Addendum Number Three

To The Drawings and Specifications for
St. Mark's Charter School Remodel – St. Mark's, Kansas
Renwick Unified School District # 267

Issued: October 27, 2008

HANNEY & ASSOCIATES ARCHITECTS

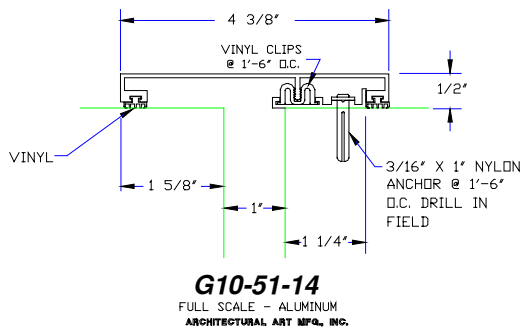
- b. Providing deck supports similar to detail 9/S7.1.
 - 1.3.3 The Roofing Contractor shall flash and dry in.
- 1.5 A question was asked if the bar joist for the Storm shelter roof been designed to not need shoring when the 7" concrete slab is poured on top? The response is that the joist capacity is noted on plan (1165/610 plf). Means and methods are the contractor's responsibility and to review with the joist fabricator.

1 DETAIL-EXPANSION JOINT
N.T.S.

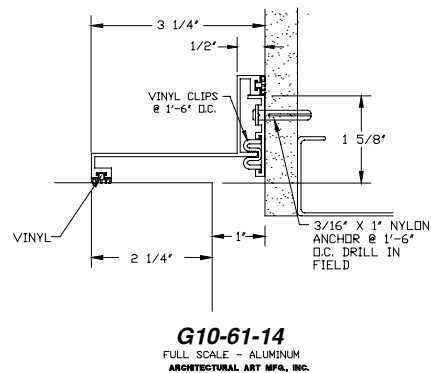
2.2.4 Expansion Joint Covers shall be provided for the walls as well as the floors. The following two details shall apply.

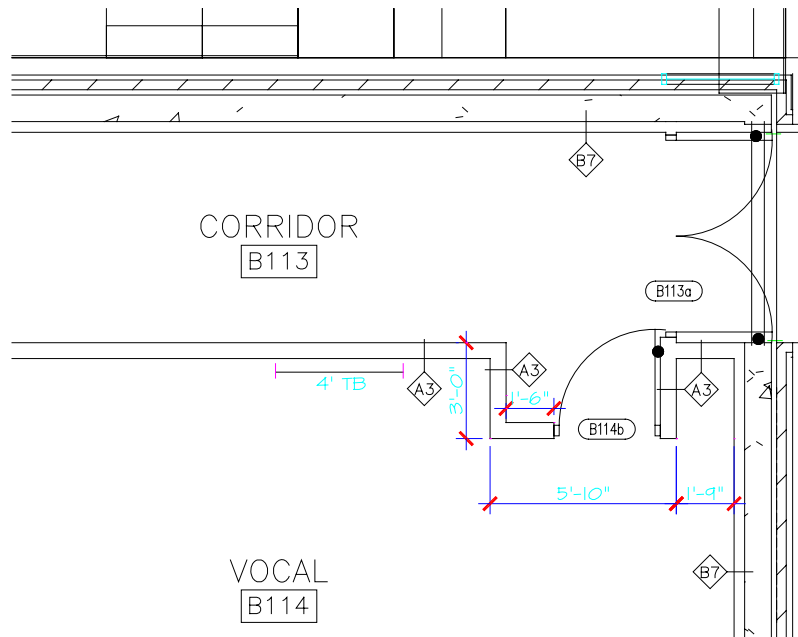
3.1.2 Sheet A6.4 has been revised and is being reissued with this addendum as A6.4R.

B AREA "B" ROOF FRAMING PLAN

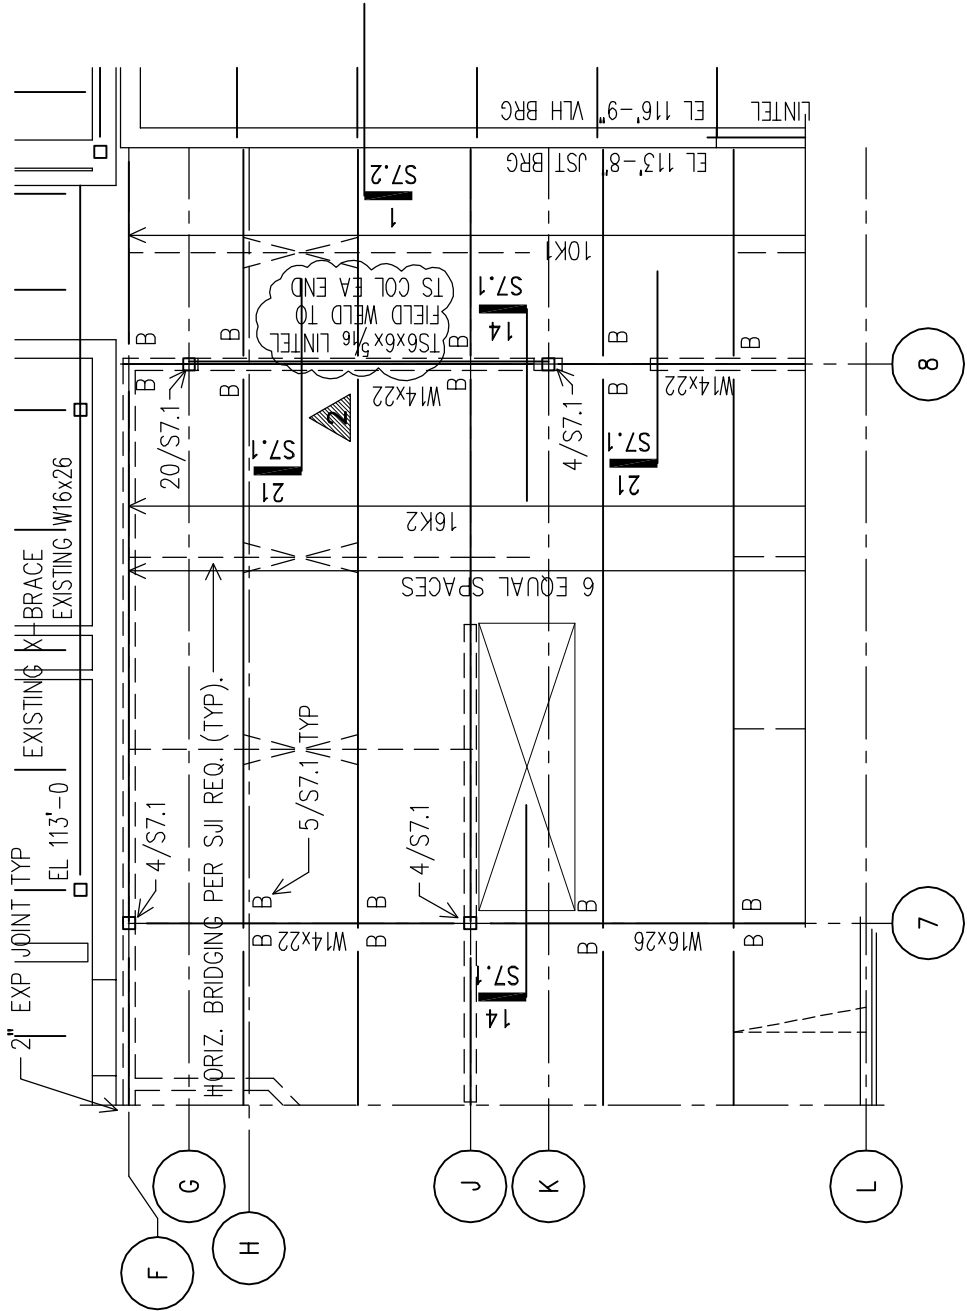
- 1.3 New roof drains in existing Roof 3
 - 1.3.1 The Plumbing Contractor shall be responsible for providing and installing the (3) new roof drains added in this addendum.

- 1.3.2 The General Contractor shall be responsible for
 - a. Removing and replacing a portion of the ceiling and lights in the two classrooms as required for the Plumber to install new roof drains and leaders. The rooms are located in the north end. The first classroom is located just north of the new Administration. The second room is a computer lab located across the hall to the East from the first room.
